MANDATORY SERVICE BULLETIN

MSB 42-148/1

MSB 42NG-094/1

Replacement of the main landing gear (MLG) and nose landing gear (NLG) retaining rings.

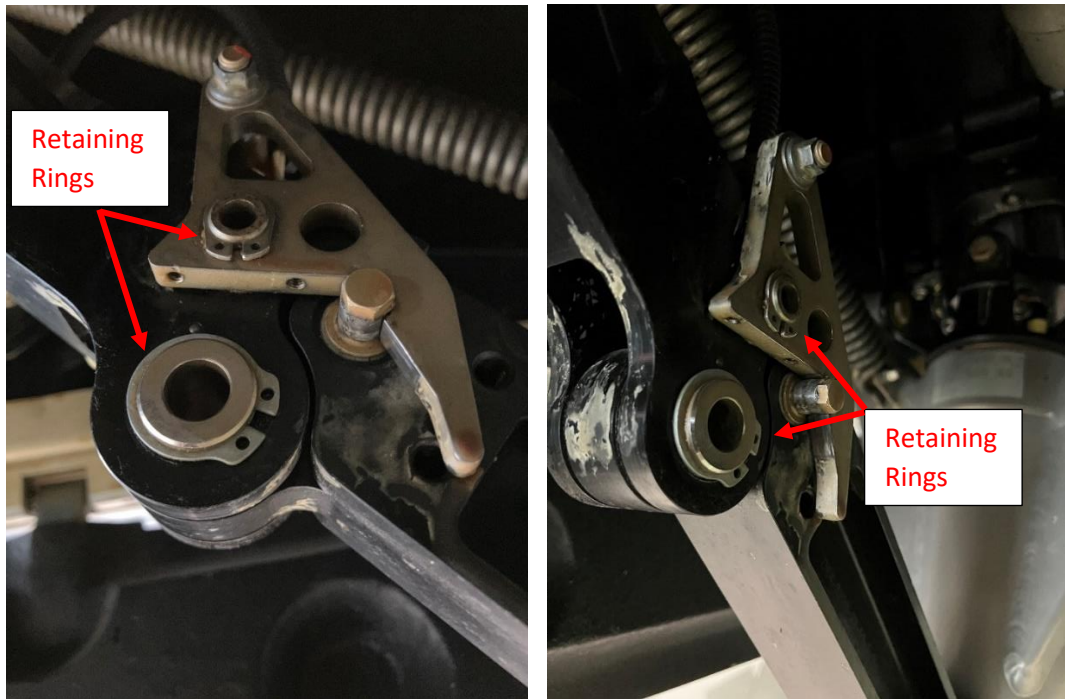
1	Pull and tag the GEAR circuit breaker to prevent inadvertent landing gear operation.
2	Locate the retaining rings. See Figure 1 for MLG locations and Figure 2 for NLG locations.   Figure 1: MLG Retaining Rings

3	Replace one retaining ring at a time.
4	Remove the retaining rings from the MLG legs and NLG leg as per the figures. (Refer to Figures 1 and 2 for location)
5	CAUTION: Do not remove or move shafts while replacing retaining rings: Clean the grooves of the bearing shafts. Inspect the folding stay and bearing shafts for general condition before installing the new retaining rings. NOTE: If for any reason the folding stay, and/or the bearing shaft needs to be removed for repair / replacement / further inspection, perform work in accordance with AMM section 32-00, then proceed to step 6.
6	NOTE: Do not overstretch the retaining rings during installation. Open the rings only enough to fit over the shaft when installing. Install the new retaining rings. Make sure the retaining rings properly engage into the grooves of the bearing shafts.
7	Clean working areas, check for foreign objects.
8	Check all altered, replaced, repaired parts for proper function.

Quantity	Part Number	Description
4	DIN471-10-MZP	DIN 471-10x1.0-MZP, Retaining ring (MLG Brace Assy LH and RH)
4	DIN471-20-MZP	DIN 471-20x1.2-MZP, Retaining ring (MLG Brace Assy LH and RH)
2	DIN471-18-MZP	DIN 471-18x1.2-MZP, Retaining ring (NLG Brace Assy)
2	DIN471-10-MZP	DIN 471-10x1.0-MZP, Retaining ring (NLG Brace Assy)
